Use on Review 10-A-18-UR

MPC FILE NO. 10-A-18-UR

PELLEAUX ESTATES
RESUBDIVISION OF LOT 5R2

MEMORANDUM

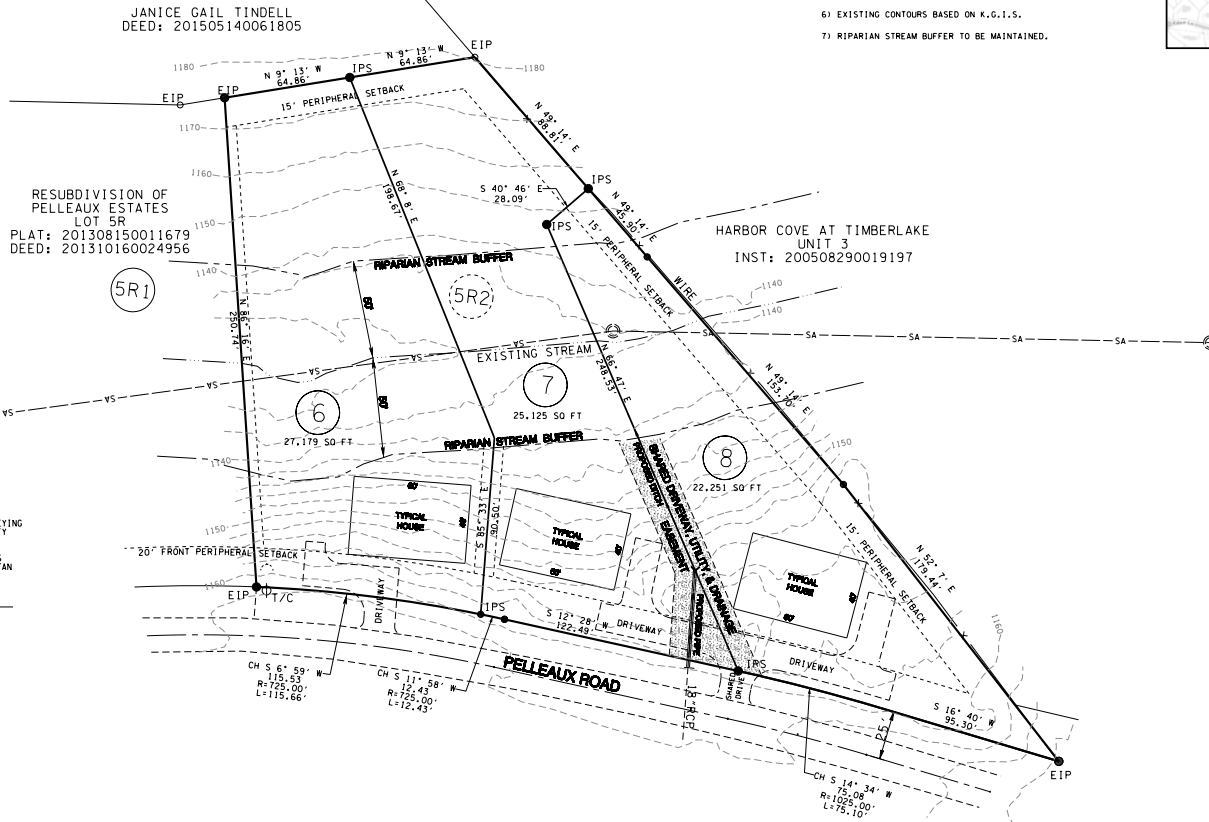
This is in regard to sight distance at the three new lots on Pelleaux Road being created by the subject re-subdivision. Garret Tucker of Robert G. Campbell and Associates had staked the property corners and driveway centerlines for each of the three lots (#s 6, 7 and 8). I checked the available sight distance at each driveway location. All measurements were made at the edge of Pelleaux Road using a driver's eye height of 3.5 feet and an approaching vehicle target height of 3.5 feet. The posted speed limit on Pelleaux Road is 30 MPH, so the required sight distance is 300 feet. The table below summarizes my findings, and I have attached a figure for clarity.

Lot #	Sight distance		Comments
	To left (south)	To right (north)	
6	Greater than 400 feet	225 feet	Sight distance to right is restricted by combination of crest vertical curve and horizontal curve with cut bank.
7	Greater than 400 feet	270 feet	Sight distance to right is restricted by combination of crest vertical curve and horizontal curve with cut bank.
8	310 feet	370 feet	Sight distance to right is restricted by crest vertical curve. Sight distance to left is restricted by vegetation within site frontage and on adjacent property.

Based on my field review there are some deficiencies. I will be glad to meet with the engineer in the field to discuss these findings. Let me know if you have any questions.

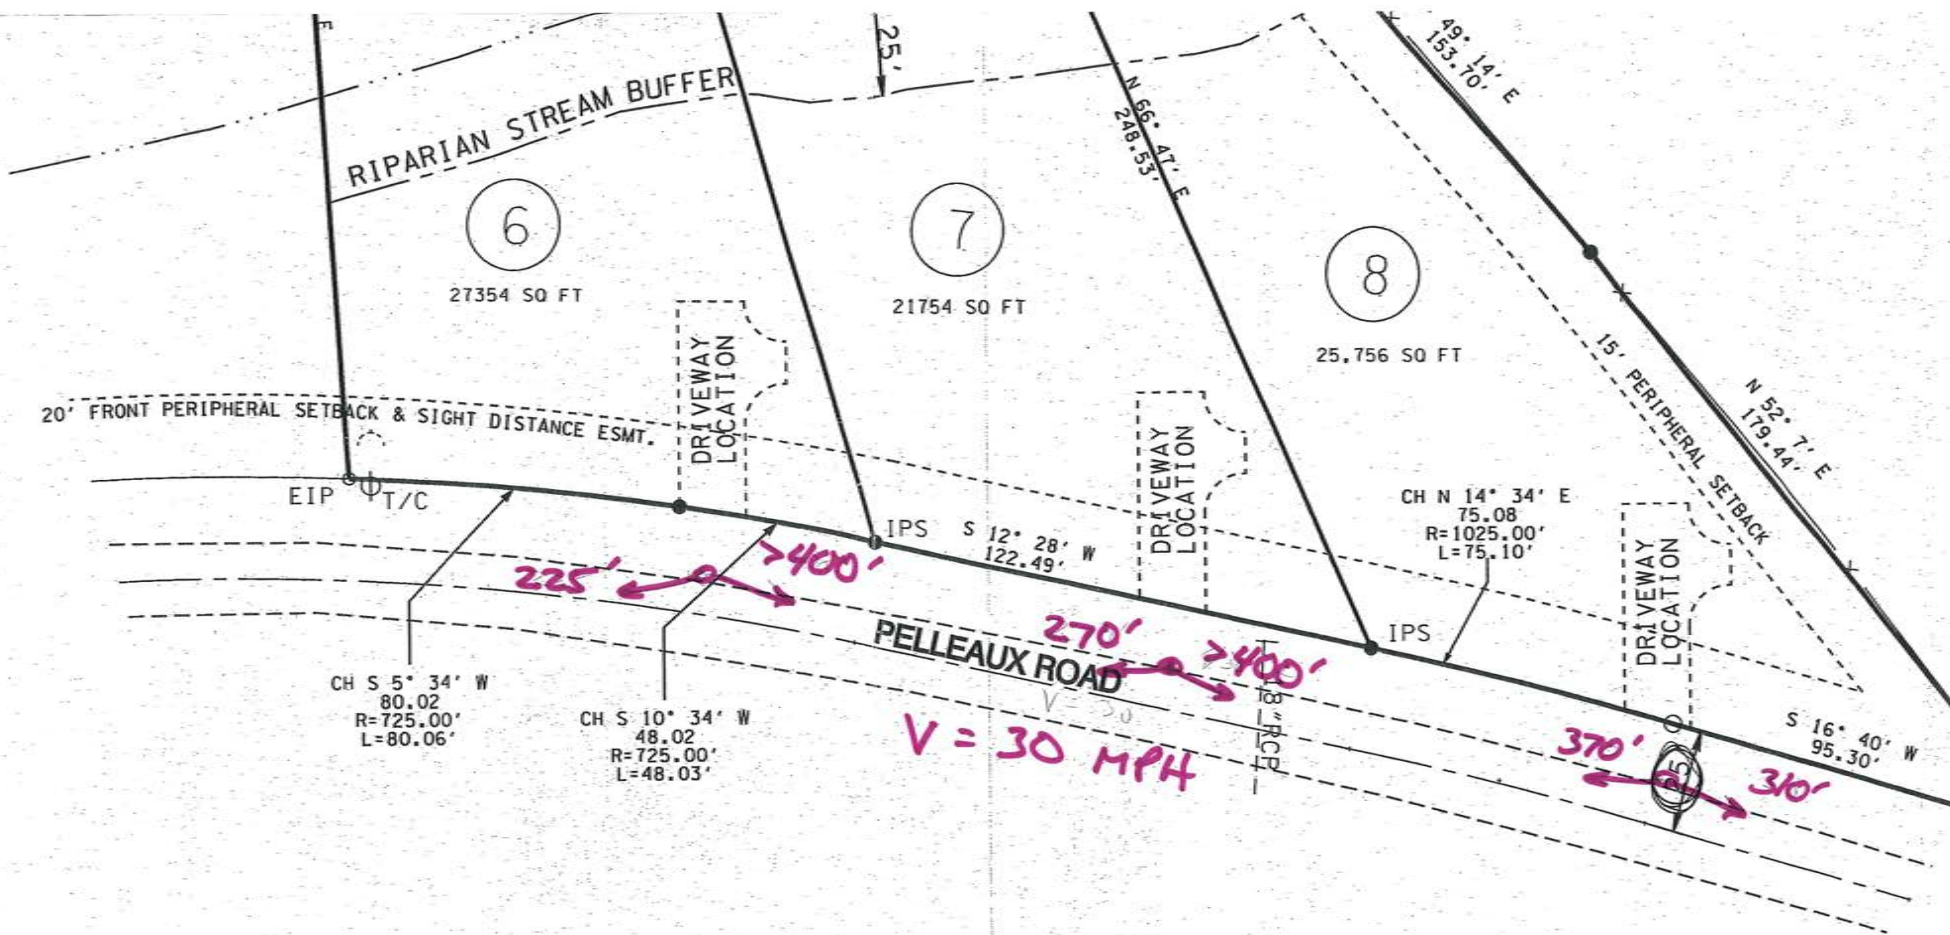
Our first concern is public safety. The property is located in a low lying area between two crest vertical curves. (See attached pictures) This limits the visibility of approaching vehicles while pulling out from the driveways. On 9/13/2018 John Sexton with Knox County Engineering conducted a sight distance calculation for the 3 proposed driveways. Two of the three proposed driveways did not meet the minimum requirements. The only driveway that met the minimum requirements was the driveway to lot 8. It barely met the requirements at 310 feet. *(300 feet minimum required distance)(*See attached document from Knox County Engineering). The only reason this driveway met the sight distance minimum was that I had recently trimmed the trees at the corner of my property. (*note the engineer's comments in the attached document about vegetation on adjacent property). The latest site plan has different driveway locations, but the driveway for lot 6 was moved in the wrong direction which would actually decrease sight distances. (*Note the map from Knox county engineering and the new site plan map by the applicant). The shared driveway was created but would still have site distance limitations from vegetation on the adjacent property and it was possibly moved too far to have a safe sight distance past the crest vertical curve. This shared driveway easement would also create problems for future property owners due to determining who would maintain the driveway. We would like to request that Knox county engineering verify the new sight distances because there appears to be some discrepancies to the original sight distance performed on 9/13/2018 and the new site plan by the applicant and his surveyor.

Our second concern is the storm water runoff that will be created by 3 new houses and driveways versus only one on this property. The runoff from 3 residential rooftops and concrete driveways will create increased flooding issues for downstream property owners that are near the creek. There is a blue line stream that runs through this property which is Spring Creek. According to the Knox County Storm water management manual section 6.3.2.1 a 50ft minimum width stream buffer shall be provided along each side of the stream. According to the MPC file 6-H-09 the 50 feet stream buffer would come almost to Pelleaux Rd and would not allow adequate room for a residence on lot 6. However, the new site plan shows the 50 feet stream buffer far enough from the road for a residence to fit. There are also some discrepancies here that need to be addressed. We would like to request that the stream buffer distance is also verified by Knox county engineering. Also, due to over 1 acre of property being disturbed this property could possibly fall under the requirements for a storm water management plan.

Our third concern is the overhead fiber optic and cable lines that run through the property. (*See attached pictures).These lines have not been addressed by the applicant. These lines should have a prescriptive easement due to the length of time they have been on the property. These lines would prevent any houses from being built on any of the proposed building sites without being moved.
